To: T10 Technical Committee
From: Steven Fairchild, HP (steve.fairchild@hp.com)
Date: 11 October 2002
Subject: Expander Configuration Details

The purpose for this document is to define the topology addressing details for the edge and fanout expanders. Most of the wording is to clarify existing concepts, with the exception of a new section on configuration of expander route tables within edge and fanout devices.

Figure X – Edge expander device set

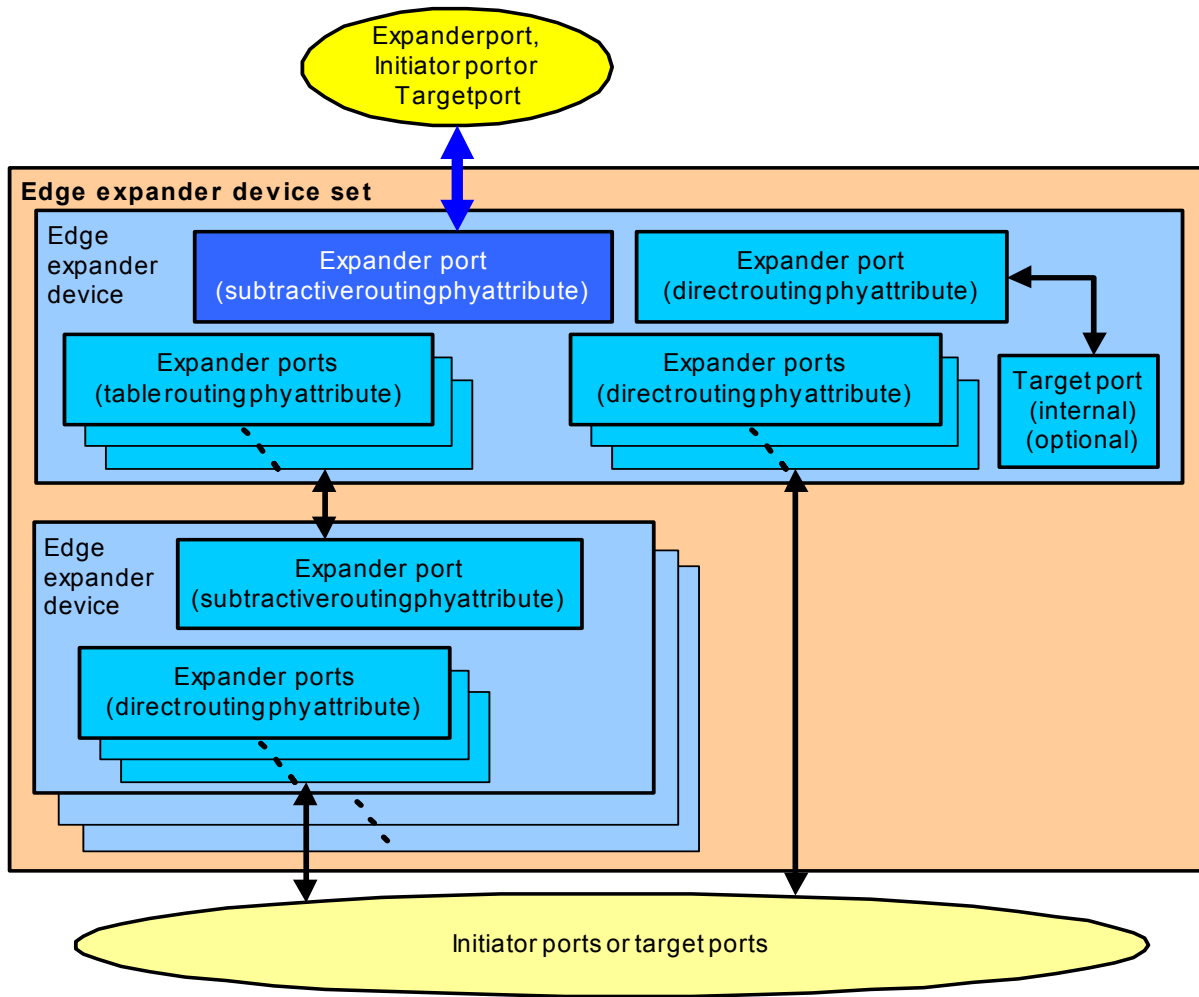
Figure X shows an edge expander device set.

4.1.7.1 Edge expander device set

One or more edge expander devices may be grouped into edge expander device sets. The edge expander device sets are bounded by the direct routing phys that are either attached to end devices or not attached to any device. Edge expander device sets are further bounded by the phys supporting subtractive routing that are:

- a) attached to the phys of a fanout device;
- b) attached to the phys supporting subtractive routing on another edge expander device set;
- c) attached to an end device; or,
- d) unattached.

The phys that support table routing within an edge expander device provide attachments to other edge expander devices in the edge expander device set.

The number of devices attached to an edge expander device set may not exceed 64. (see 4.1.9).

Figure 13 – Maximum expander topology

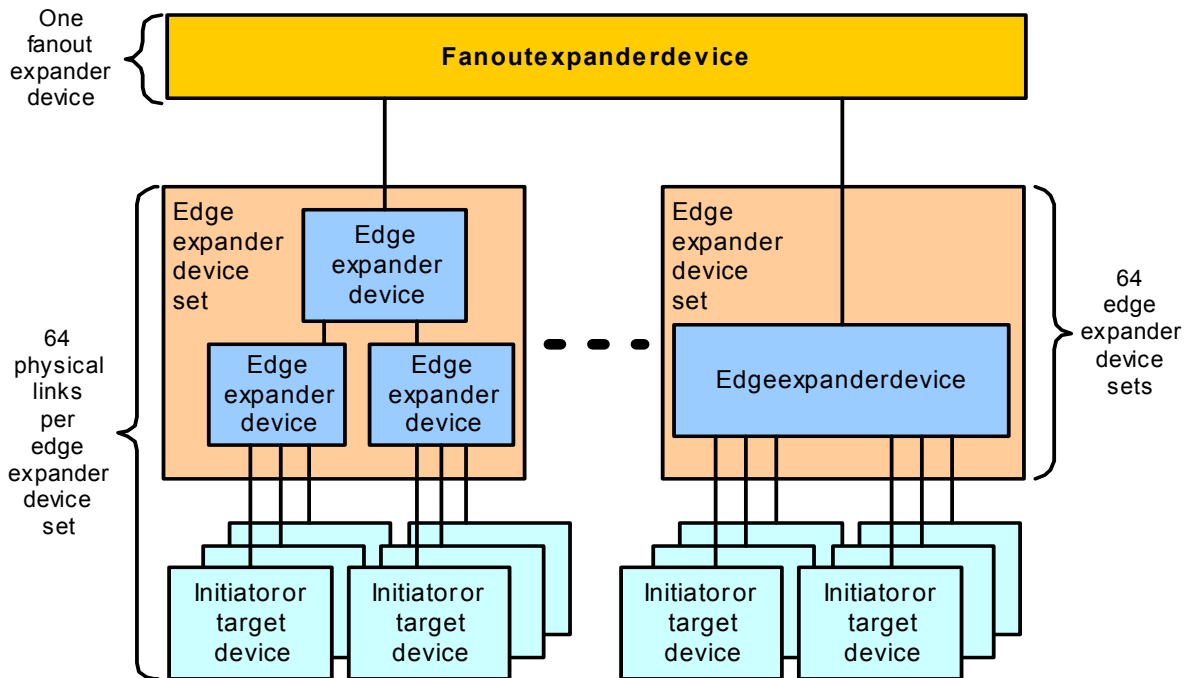
Figure 13 shows a SAS domain with the maximum number of expander devices.

No more than one fanout expander device shall be included in a SAS domain. The fanout expander device may be attached to up to 64 edge expander device sets, initiator devices, or target devices.

Each edge expander device set shall contain no more than 64 physical links to edge expander devices, initiator devices, or target devices. Each edge expander device set shall not be attached to more than one fanout expander device. An edge expander device set may be attached to one other edge expander device set if that is the only other edge expander device set in the SAS domain and there are no fanout expanders in the SAS domain.

Figure 14 – Fanout expander topology

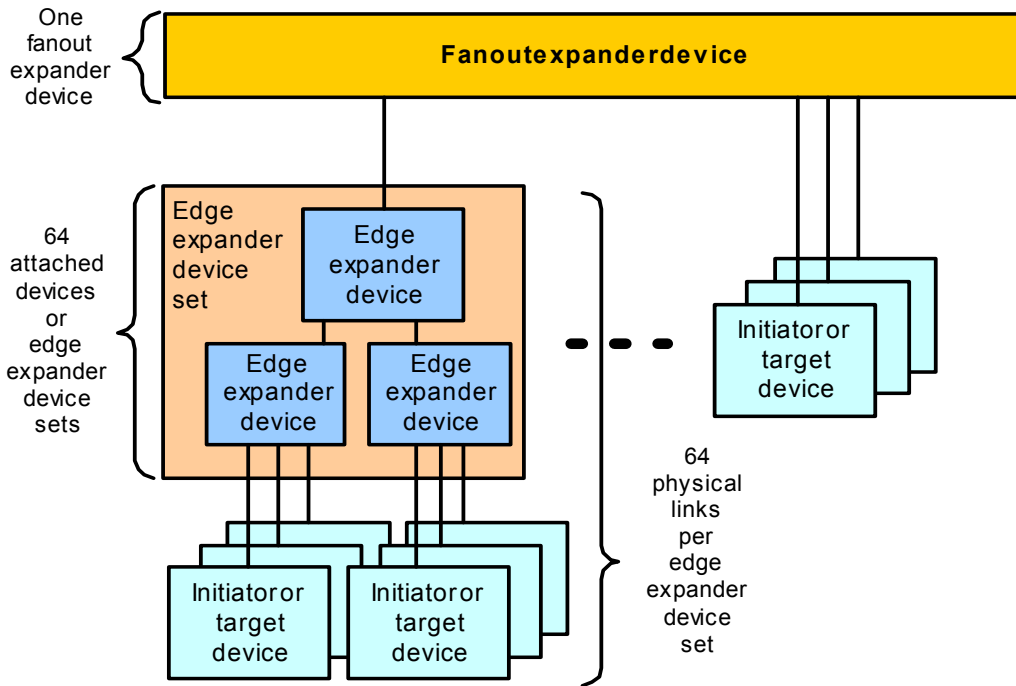
Initiator devices and target devices may be attached directly to the fanout expander device, as shown in figure 14.

Figure 15 – Edge expander device set topology

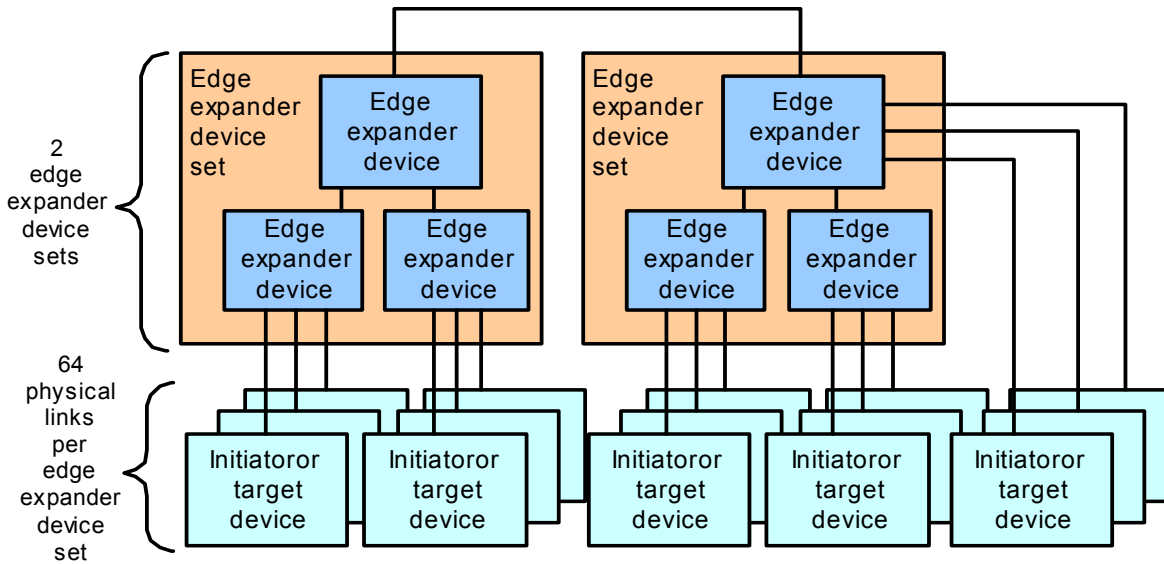
Initiator devices and target devices may be attached to any of the edge expander devices within an edge expander device set and at most, two edge expander device sets may be attached together without a fanout expander, as shown in figure 16.

Figure X – Expander route table example

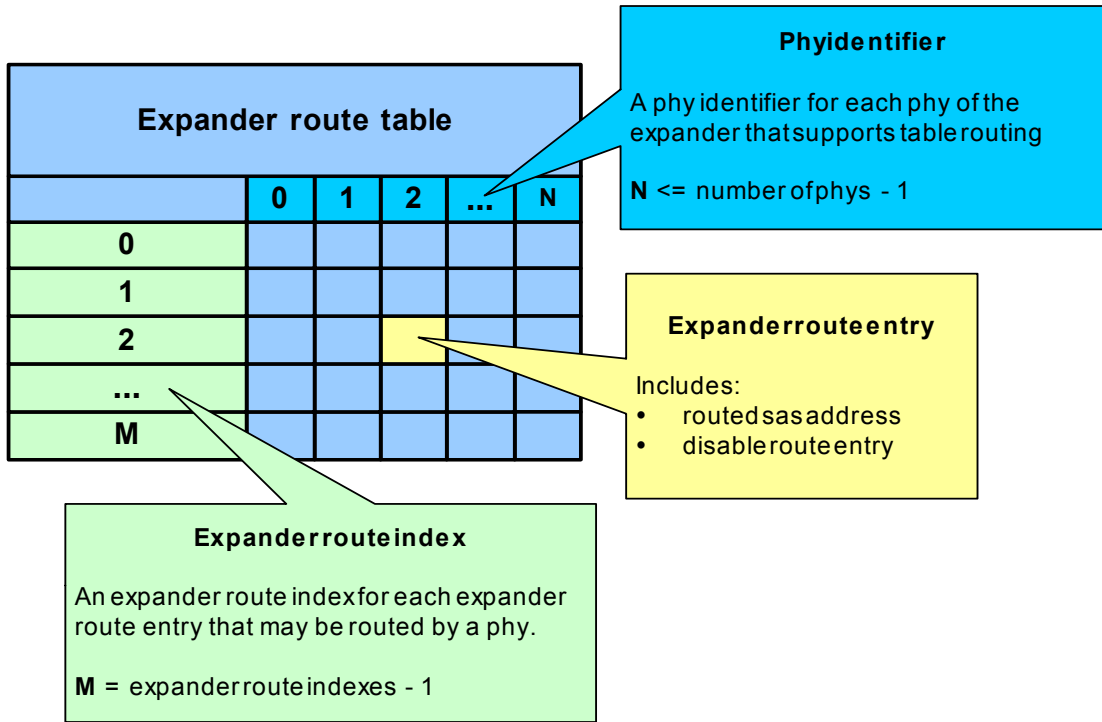
Figure X shows a representation of an expander route table.

An expander device that supports the table routing method (see 4.1.9.1) shall contain an expander route table. The expander route table is a structure that provides an association between destination SAS addresses and expander phy identifiers. Each association represents an expander route entry.

An expander device indicates its ability to maintain the expander route entries and define the size of the expander route table (see 9.4.4.2).

An initiator device may reference a specific expander route entry within an expander route table (see 9.4.4.5 and 9.4.4.9).

Figure Y – Expander route index order

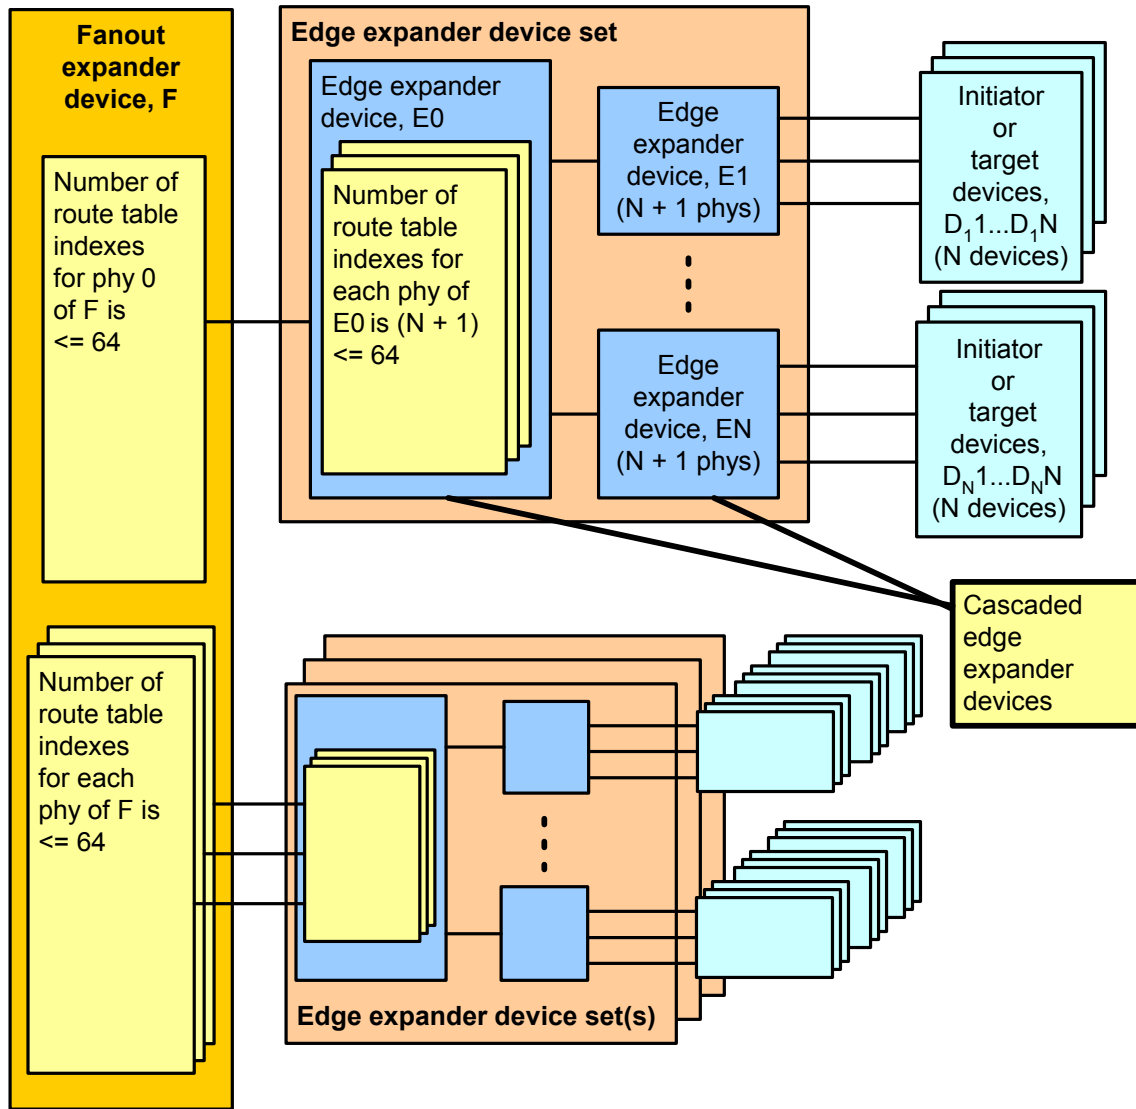
As an example, figure Y is used in association with Table Y to show the expander route index order for the edge expander, E0.

Table Z in association with Figure Y shows the expander route index order for the fanout expander F.

Expander Route Index	Routed SAS Address Description
0	Routed SAS address, (e.g., E0) of the device attached to phy 0 of the attached edge expander, (e.g., E1). In figure Y the DISABLE ROUTE ENTRY bit is set for this entry; because, E0 is a self-reference.
1	Routed SAS address, (e.g., D ₁ 1) of the device attached to phy 1 of the attached edge expander, (e.g., E1).
2	Routed SAS address, (e.g., D ₁ 2) of the device attached to phy 2 of the attached edge expander, (e.g., E1).
N	Routed SAS address, (e.g., D ₁ N) of the device attached to phy N of the attached edge expander, (e.g., E1).

Expander Route Index	Routed SAS Address Description
0	Routed SAS address, (e.g., F) of the device attached to phy 0 of the attached edge expander, (e.g., E0). In figure Y the DISABLE ROUTE ENTRY bit is set for this entry; because, F is a self-reference.
1	Routed SAS address, (e.g., E1) of the device attached to phy 1 of the attached edge expander, (e.g., E0).
2	Routed SAS address, (e.g., E2) of the device attached to phy 2 of the attached edge expander, (e.g., E0).
N	Routed SAS address, (e.g., EN) of the device attached to phy N of the attached edge expander, (e.g., E0).
Routed SAS addresses for phys with table routing attribute and a cascaded expander device.	
N + 1	Routed SAS addresses for an edge expander, (e.g., EN). This edge expander (e.g., EN) is in turn attached to a cascaded edge expander, (e.g., E0) through phy 0.
n	Routed SAS addresses for an edge expander, (e.g., EN). This edge expander (e.g., EN) is in turn attached to a cascaded edge expander, (e.g., E0) through phy N.
